UNITED STATES
NUCLEAR REGULATORY COMMISSION
WASHINGTON, D. C. 20555

OYSTER CREEK NUCLEAR GENERATING STATION, UNIT NO. 1

AMENDMENT TO PROVISIONAL OPERATING LICENSE

Amendment No. 39
License No. DPR-16

FIGURE 3.10-1

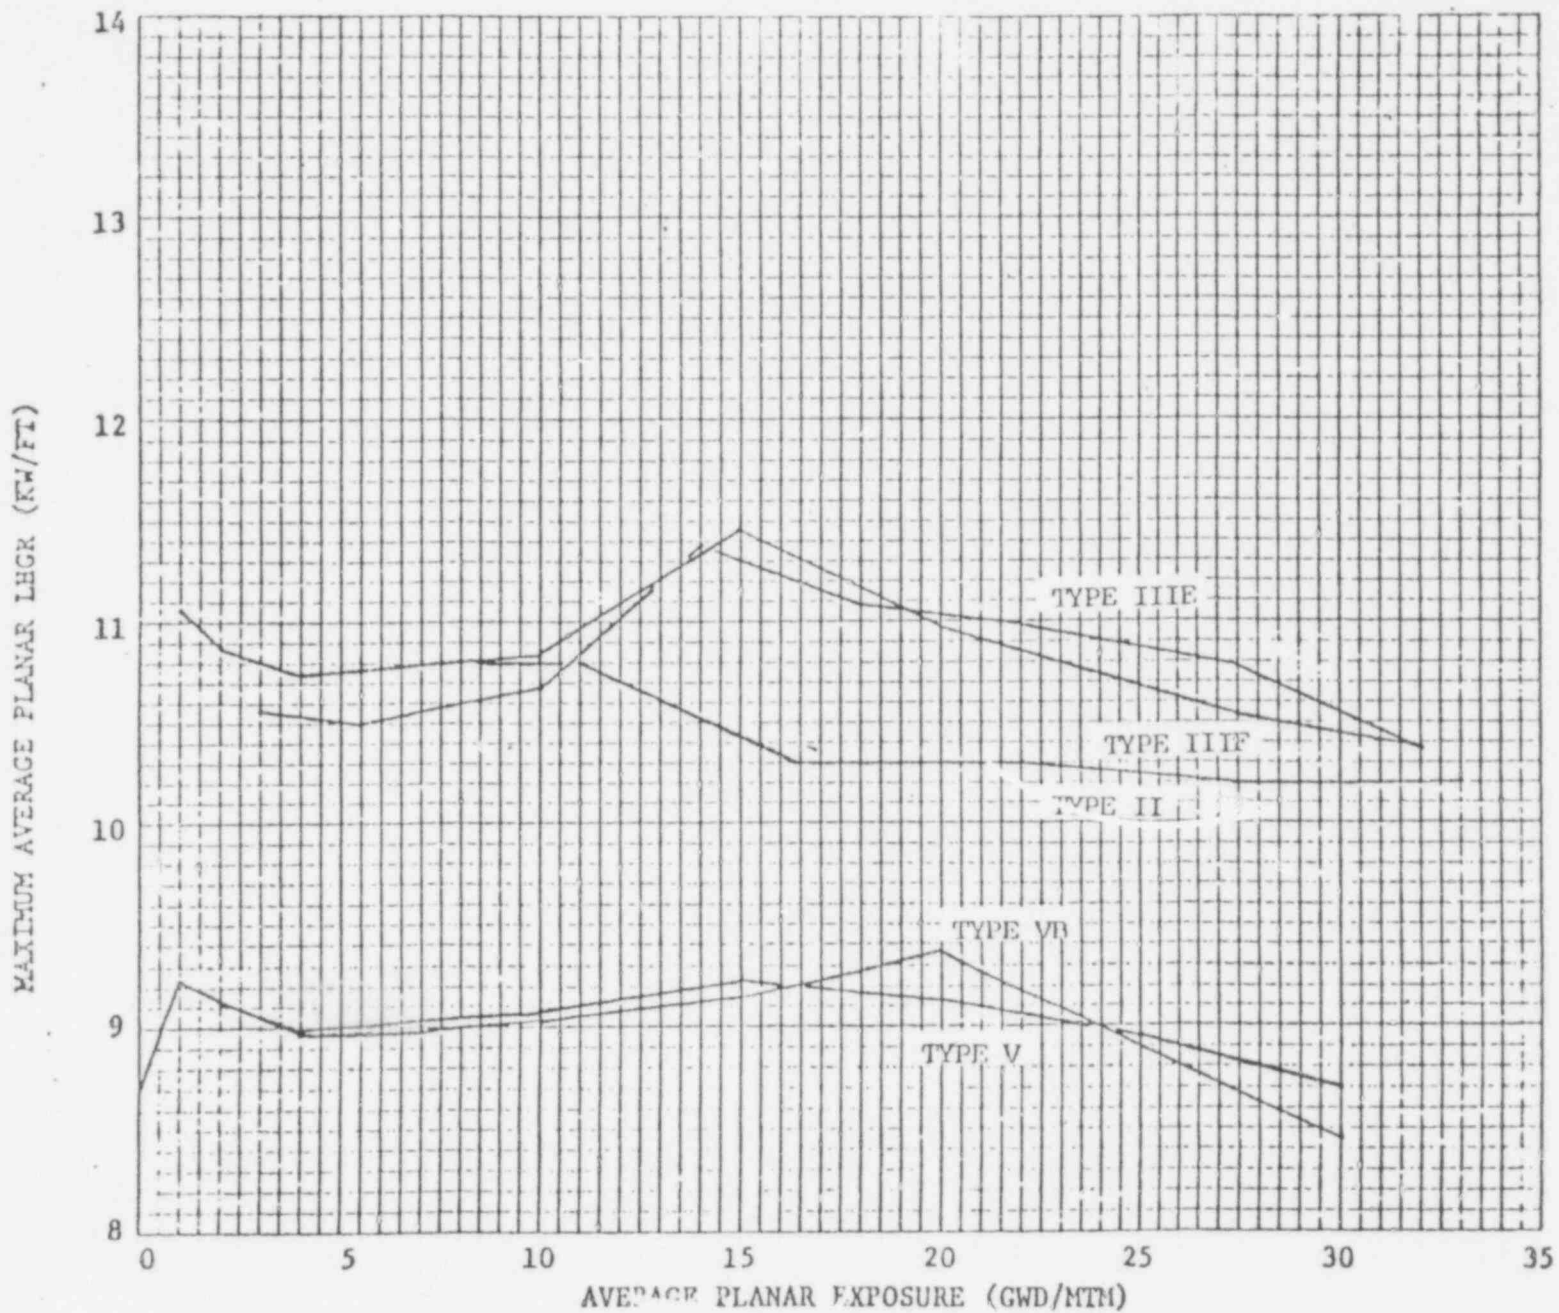
<u>REMOVE</u>	<u>INSERT</u>
2.3-3	2.3-3
3.1-8	3.1-8
3.10-1	3.10-1
3.10-2	3.10-2
3.10-9	3.10-9
	(Figure 3.10-1)
3.10-10	--
(Figure 3.10-2)

During power operation, the average linear heat generation rate (LHGR) of all the rods in any fuel assembly, as a function of average planar exposure, at any axial location shall not exceed the maximum average planar LHGR (MAPLHGR) limit shown in Figure 3.10-1. If at any time during power operation it is determined by normal surveillance that the limiting value for APLHGR is being exceeded, action shall be initiated to restore operation to within the prescribed limits. If the APLHGR is not returned to within the prescribed limits within two (2) hours, action shall be initiated to bring the reactor to the cold shutdown condition within 36 hours. During this period surveillance and corresponding action shall continue until reactor operation is within the prescribed limits at which time power operation may be continued.
